Accessibility Survey

City of Downey Quoit Street - Orizaba Avenue To Downey Avenue

Date of Inspection 1/29/2017

Change In Level East Of Orizaba Avenue @ 33.925045126847, -118.147358894348

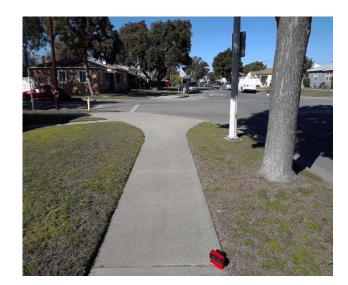
There is a change in elevation greater than recommended value.

On-Site Finding 0.50 inches

Ensure that the change in elevation is within the recommended value.

Recommendation Up to 0.25 inches

Bottom Landing

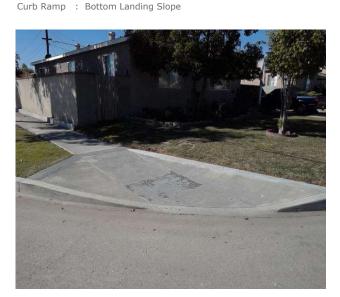
The bottom landing of the curb ramp is on the street, and the slope of the bottom landing is not compliant.

On-Site Finding 7.40 percent

Ensure the bottom landing slope is compliant and provides a smooth transition.

Recommendation Up to 5.00 percent
